**MATANUSKA-SUSITNA BOROUGH  
PLATTING BOARD  
AGENDA**

**AUGUST 4, 2016**

- C. **MICHAEL & KRISTLE LOTZER** (owner/petitioner): The request is to divide Lot 2 & Lot 3, Block 11 and Tract A, Potter Place Add #2 (Plat #86-199) into 8 new lots to be known as **SIDETRACK SUBDIVISION**, containing 17.38 acres +/- . The petitioner is also requesting to vacate the 30 x 400-foot Public Use Easement along the north side of proposed Lots 1 & 2 and the 14-footwide pedestrian easement within proposed Lots 2, 3&4. Located within Sec 17, T17N, R02W, S.M. AK, lying south of the Parks Highway, north of W. Misty Lake Road and adjoining the north side of S. Leora Drive. Community Council: Meadow Lakes, Assembly District: #7 Randall Kowalke
- D. **Title 43 Proposed Amendment and changes.**

**EXHIBIT H-2**

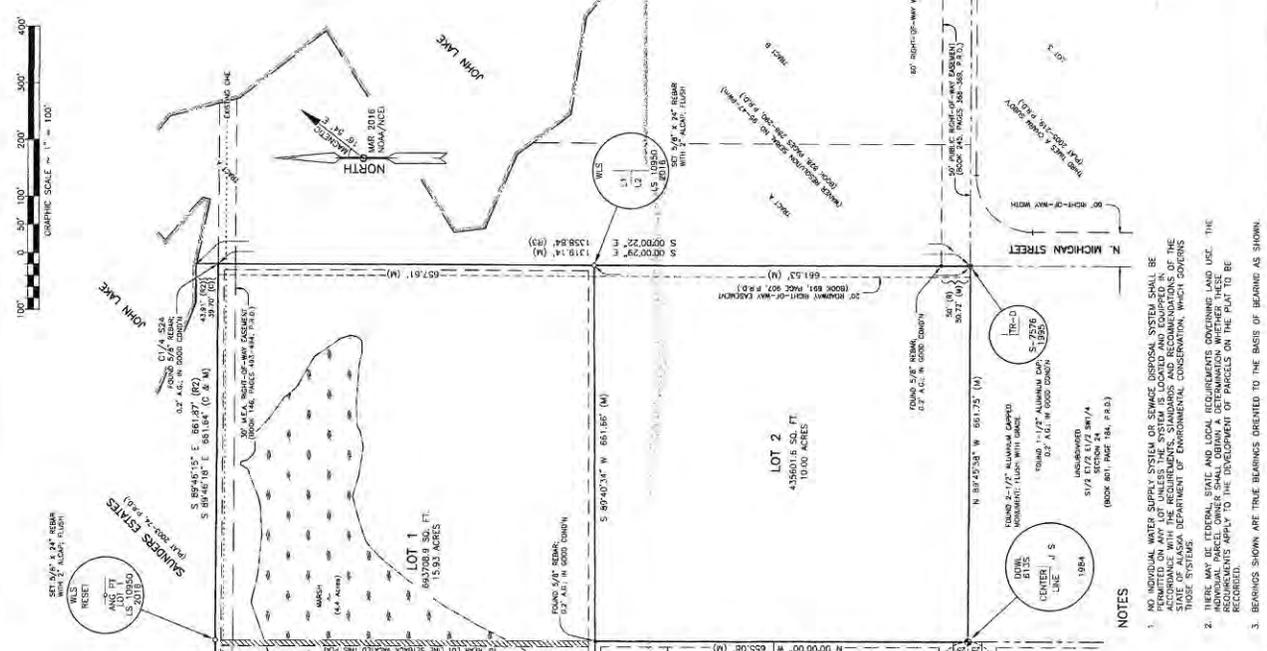
Tammy: What is shown on the plat as a road easement on the east is actually a private easement. Do you want to revise your comments? Thanks. A.

We have reviewed the plat for Lazy A Subdivision. MEA is requesting a 15' easement be added along the 20' Roadway Right-of-Way. This would allow us to bring power to Lot 2.

DETAIL 02 - LOT 2 AS-BUILT  
SCALE: 1" = 50'

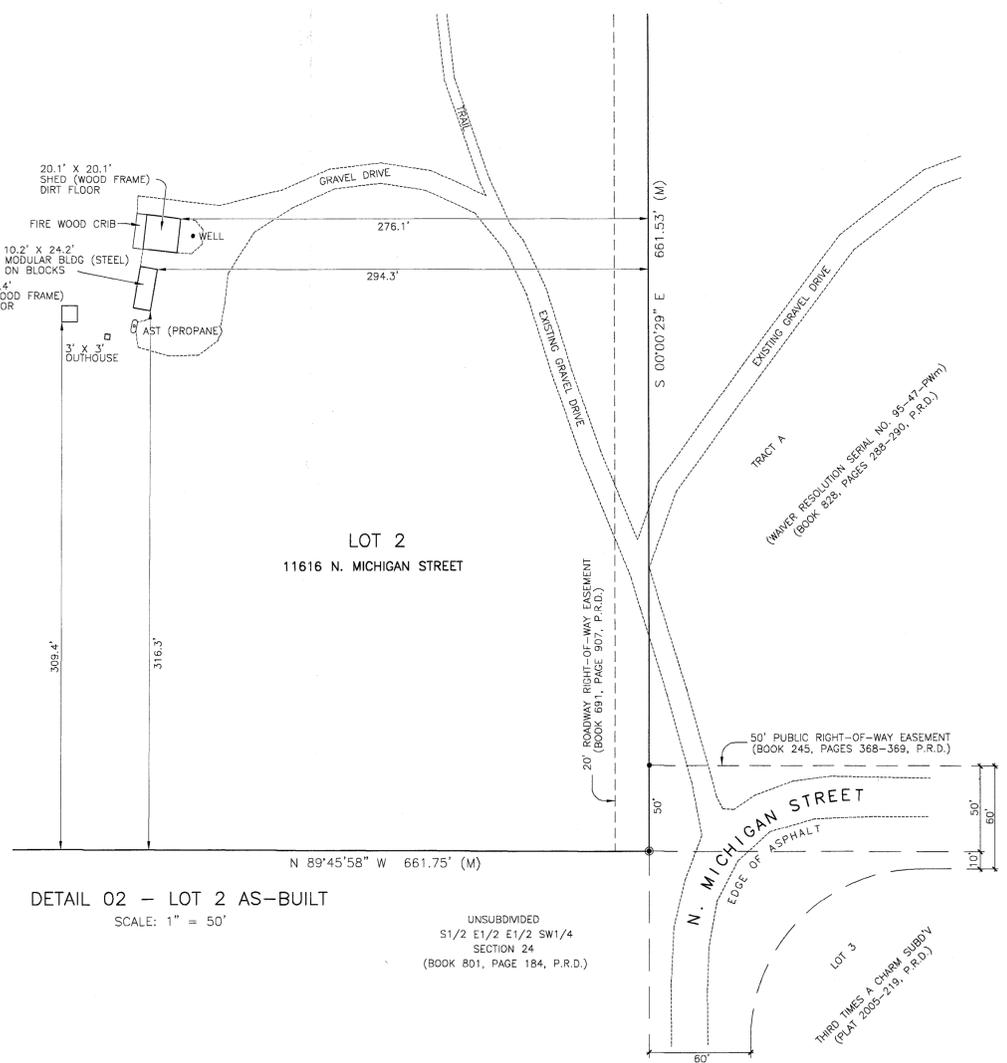
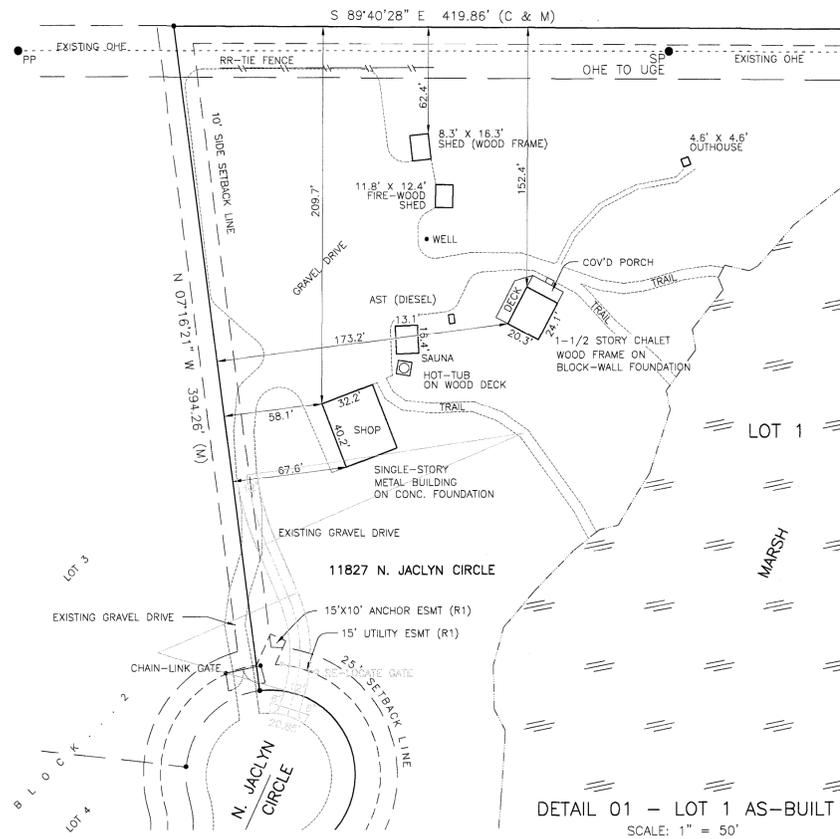
Physical access onto Mr. Buckwalter's property is currently by way of an existing and historic 12' wide gravel driveway which extends northerly from N. Michigan St. (Please refer to Attachment 1 – Sheet 2 of 2, Detail 02 – Lot 2 As-built).
